Access Compliance Report

Public Rights-of-Way

(Curb Ramps)

Intersection ID: 11099	Main Street: DENSON_PL	Cross Street: TIPPERARY_PL	Location: W
ADA ID: C4891E29B444	Ramp Type: Para	Initial Pass/Fail: Fail	Overall Compliance: No
Codes/Mitigation Info/Possible Solution		Field Measurements/Component Compliance	
Severity Score: 13.75

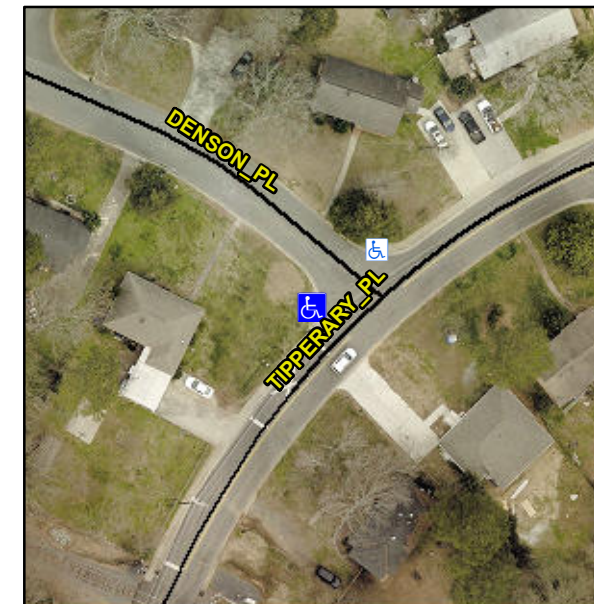
Surveyor Notes:

LT RP < 5%

PROW/ADA:

R304.3.2, R304.5.3

Possible Solutions:

Remove & Replace Entire Ramp.
